SERVICE BULLETIN

APPLICABILITY: 2019-22MY Ascent

NUMBER: 07-219-23R

SUBJECT: Genuine Alternative Battery Replacement

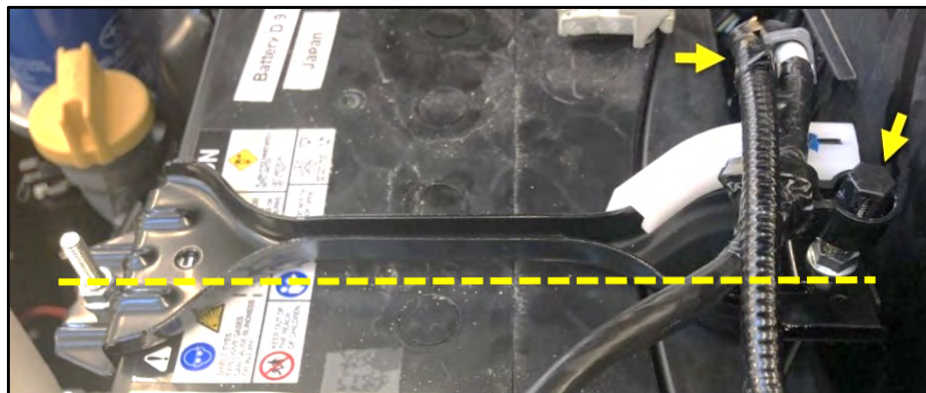
STEP 5: Assemble the **ORIGINAL** battery holder, **NEW** rear holding rod (p.n. 82161SJ000), and the ORIGINAL front holding rod as shown below. The original rod nut can be transferred to the new rear holding rod.

NOTE: DO NOT discard the original rear rod. This part is to be returned to be returned to the customer.
